Japan's position and proposal on draft of OBD-gtr

**Ministry of the Environment(MOE), Japan
&
Ministry of Land, Infrastructure,
Transport and Tourism (MLIT), Japan**

What is Fuel system monitoring?

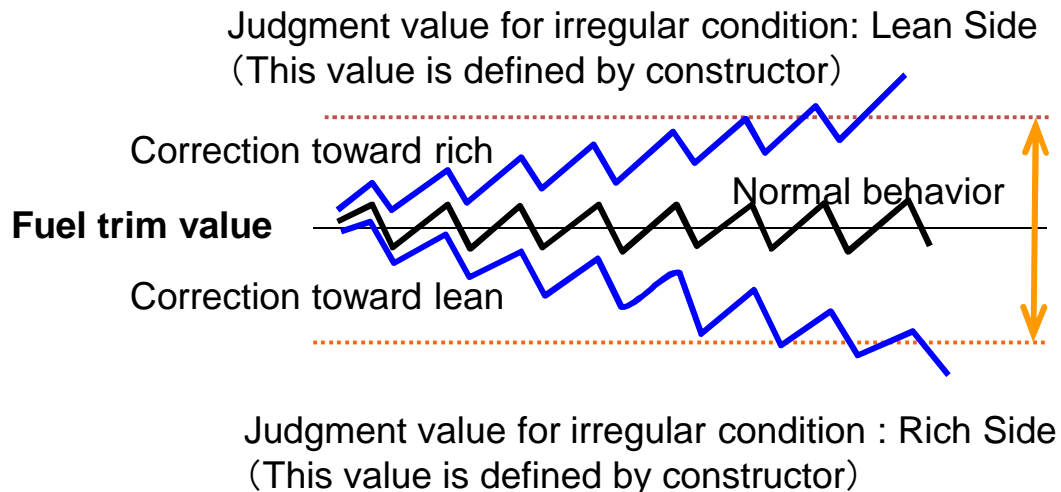
Japan believes that fuel system monitoring is significant issue and this monitoring should be included into gtr

- Checking fuel system function according to whether fuel trim value is within a certain range defined by manufacture or not.
- It is allowed to apply a specific driving mode for diagnosis.

Monitoring based on a logic if fuel system is normal and A/F F/B-control works stably ,fuel trim value must be in this range.
